Access Compliance Report

Public Rights-of-Way

(Curb Ramps)

Intersection ID: 3731	Main Street: HARRIS_CORNERS_PY	Cross Street: HARRIS_OAKS_BV	Location: NE
ADA ID: 7D393F721364	Ramp Type: Perp	Initial Pass/Fail: Fail	Overall Compliance: No
Severity Score: 8.75			
Codes/Mitigation Info/Possible Solution		Field Measurements/Component Compliance

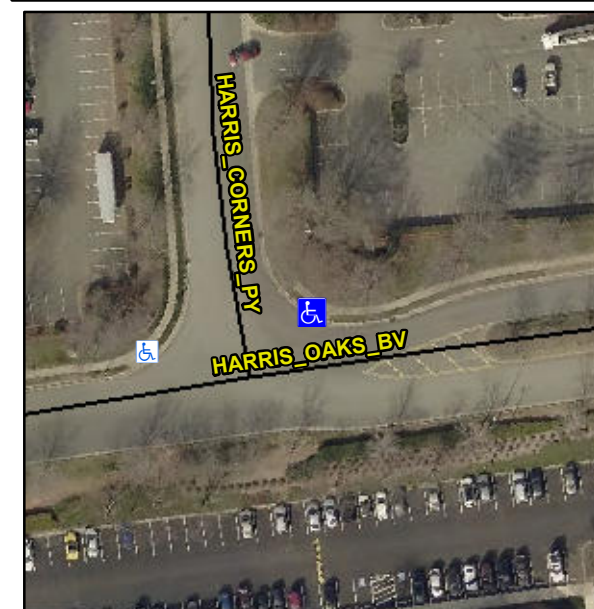
Not Found, R304.5.1

Compliance	Description	Data	Compliance	Description	Data
N/A	Ramp Length (in)	48.0	Yes	Ramp Slope (%)	8.1
No	Ramp Width (in)	47.0	Yes	Ramp XSlope (%)	0.4
N/A	Flare Type LT	N/A	N/A	Flare Type RT	N/A
N/A	Flare Slope LT (%)	N/A	N/A	Flare Slope RT (%)	N/A
N/A	Flare Traversable LT?	N/A	N/A	Flare Traversable RT?	N/A
N/A	Landing Length (in)	N/A	N/A	DWS Provided?	N/A
N/A	Landing Width (in)	N/A	N/A	DWS Contrast?	N/A
N/A	Landing Slope (%)	N/A	N/A	DWS Length (in)	N/A
N/A	Landing X Slope (%)	N/A	N/A	DWS Full Width?	N/A
N/A	Landing Curb? (Y/N)	N/A	N/A	DWS Offset (in)	N/A
N/A	Shared Landing?	N/A			
N/A	Gutter Ponding?	N/A	N/A	Gutter Slope (%)	N/A
N/A	Gutter Lip Ht (in)	N/A	N/A	Gutter X Slope (%)	N/A
N/A	Painted X Walk1?	No	N/A	Painted X Walk2?	N/A
	X Walk 1 Direction	To W		X Walk 2 Direction	N/A
N/A	X Walk 1 Width (in)	N/A	N/A	X Walk 2 Width (in)	N/A
	X Walk 1 Slope (%)	0.7		X Walk 2 Slope (%)	N/A
	X Walk 1 X Slope (%)	1.0		X Walk 2 X Slope (%)	N/A

Remove & Replace Entire Ramp.
